Namibian Marine Phosphate
(Pty) Ltd

I&AP COMMENTS AND RESPONSES FOR THE SANDPIPER MARINE PHOSPHATE PROJECT ML 170 ESIA REPORT

PROJECT NUMBER: ECC-133-377-REP-31-D

DATE: 31 OCTOBER 2022

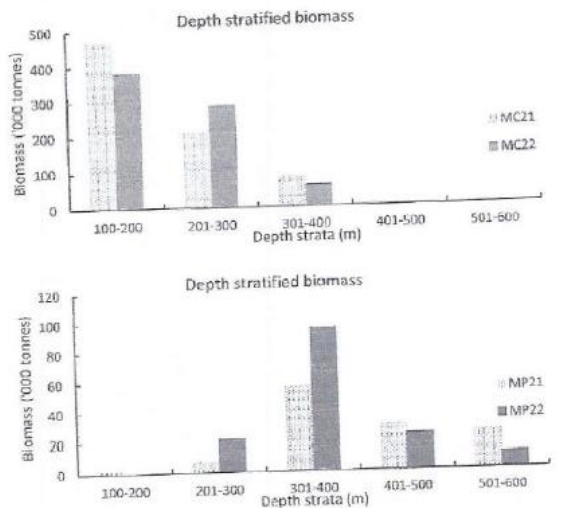
Comments	EAP/Proponent and Specialists response
<p>3. However, due to current regulations, the HM sector (fishing only permitted deeper than 200m to protect inshore fish breeding and juvenile grow out areas) is squeezed into very limited zones to catch the TAC which becomes more and more difficult due to water temperatures and movement of HM during winter conditions. The area north of 25.5 degrees is the only area where catchable shoals of HM are found during specific winter months for wet fish HM vessels and hence the risk to allow phosphate mining at that position. The area is also known to be where the large adult HM concentrate, and if marine phosphate mining is allowed to go ahead, a bigger risk of heavy metal contamination on this part of the HM resources.</p> <p>4. Considering that the proposed phosphate mining zone has also been squeezed in the southern part of the HM catching zone outside the 200m depth, this is unacceptable as it poses a direct threat to the HM sector which is known as the protein basket for the lower income in SADC countries.</p> <p>5. Also considering the proposed zone for phosphate mining is the exact area of the large adult HM biomass and poses further treats for fishery.</p> <p>6. Based on importance of food security as well as newly found job creation in the HM sector, the Wet Landed Horse Mackerel Association proposed that all fishing</p>	<p>scale of the proposed mining operations is contained within the stated areas. Any changes to that assumption used in the assessment will naturally alter the impact assessment as it changes the relative extent of impact that it could pose on the fisheries in the proximity of the mining or even if permitted in other areas.</p> <p>Namibian survey data suggests that the < 200 m depth area is an area where smaller hake are found. This indeed is a biologically known fact for hake globally (size depth relationship), though discreet spawning areas for hake and other species have not been described explicitly based on the historical and currently available information. Hake and monk for example are broadly distributed across the Namibian shelf. Sardine stocks have collapsed.</p> <p>The statement that shallow water hake is less than 50 % of MSY is incorrect – Namibian hake stocks have been in a process of rebuilding since independence – the strategy to rebuild (which has not always been followed) applies the RY strategy (replacement yield) i.e. the calculated allowable catch effectively replaces the catch each year, except that the allowed catch is reduced by 20 % (to allow surplus for rebuilding). Although the strategy is not the same for all stocks in Namibian waters, the state of the mainly commercial fish stocks is deemed generally good although stock dynamics varies between demersal and pelagic species.</p> <p>The figure below from the MFMR assessment made available for this assessment shows that the <i>M. capensis</i> stock in 100-200 m is high, similarly in the 2001 to 300 m depth zone. The fishable biomass is mainly deeper than</p>

Comments	EAP/Proponent and Specialists response																		
<p>areas outside the 200m depth restriction, where HM fishing takes place, be exclusively zoned for HM to ensure the survival of this important sector. The wet landed HM sector aligns 100% with the Namibian Blue Economy policy in terms of food security and job creation for Namibians, mining in these limited fishing areas posing a huge risk.</p> <p>7. During winter months the HM resource moves closer to shore, which makes catching areas even more difficult</p> <p>8. The risks to Southern Africa’s largest fishing resources as well as the significant potential to grow employment in this sector outweigh benefits from mining in the limited areas of HM fishing. Also, government of fellow SADC countries have a vested interest in the wellbeing of the Namibian HM resource, due to the importance of food security provided to the people of Southern Africa.</p>	<p>200 m and in fact both hake species are targeted in deeper waters than 300 m. As mentioned earlier, scale is important – the impact of the mining, assuming the mining is constrained to the areas stated, on the hake biomass in and around the 200 m depth contour is therefore in the context of scale, low. Your figure provided on the MFMR 2022 survey is noted but this does not alter the inference based on the 2020 information.</p> <div style="text-align: center;">

Figure 5 Depth-stratified biomass distributions for the two species of hake: *M. capensis* (top) and *M. paradoxus* (bottom) from the 2021 and 2022 (bottom) swept-area surveys

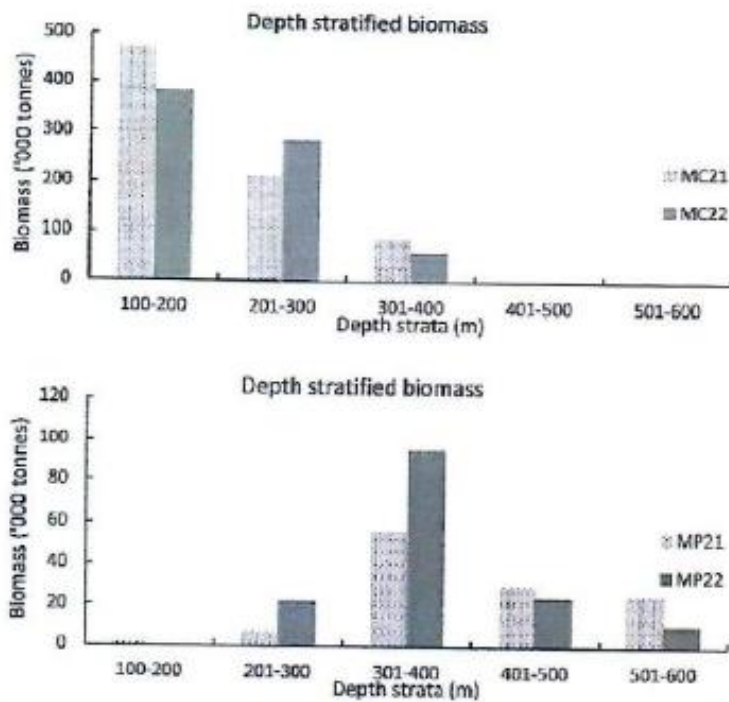
The lower graph, MP 21 and 22, refers to *Merluccius paradoxus*, which breeds in South Africa, and only comes to Namibia after reaching a certain size, going back to South Africa to breed off the West Coast Hondeklip Baai.

Proportion wise, *M. capensis* dominates the two shallower depth zones (100- 300 m) while *M. paradoxus* dominates from 401 to deeper, with normally no *M. capensis* deeper than 500 m. The two species occur almost on an equal basis in the intermediate depths of 301-400 m.
